Technical change to HDC HEEE 40/64 INSERTS

PCN-number: PCN-PB72-20200914-00-A
Date of publishing: 2020, September 14
Duration of validity: Until further notice
Revision number: 00-A

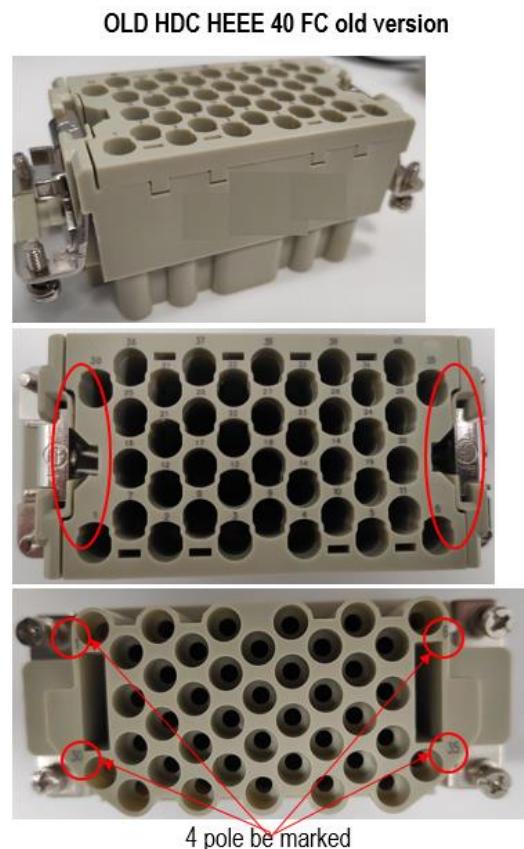
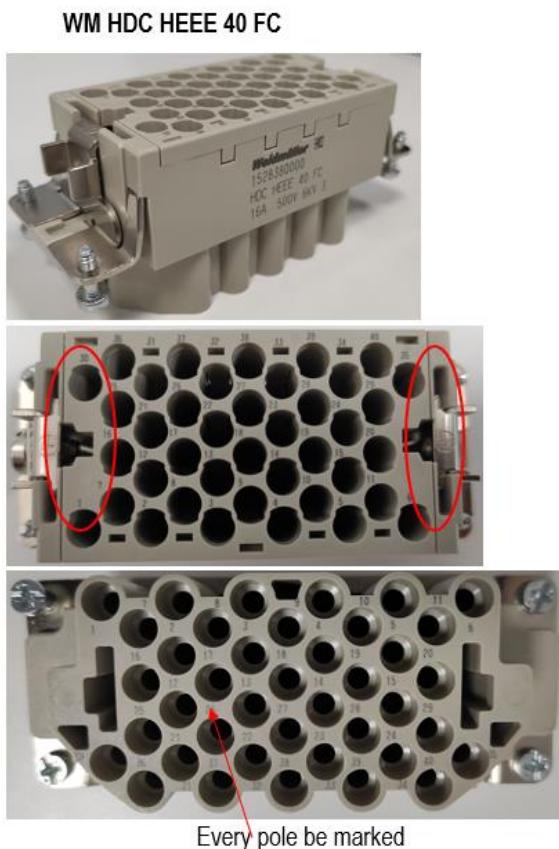
The HDC HEEE 40/64 INSERTS had in the past another outlook

In the future the inserts will look as following

WM HDC HEEE 40 MC

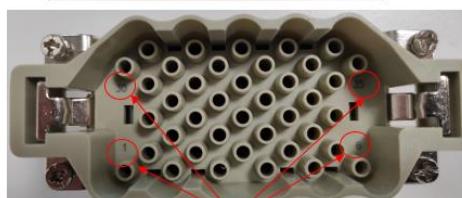
Every pole be marked

new product

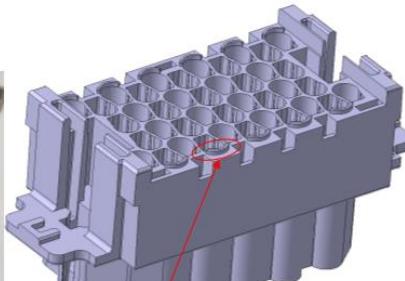
Added this structure for meet clearance and creepage
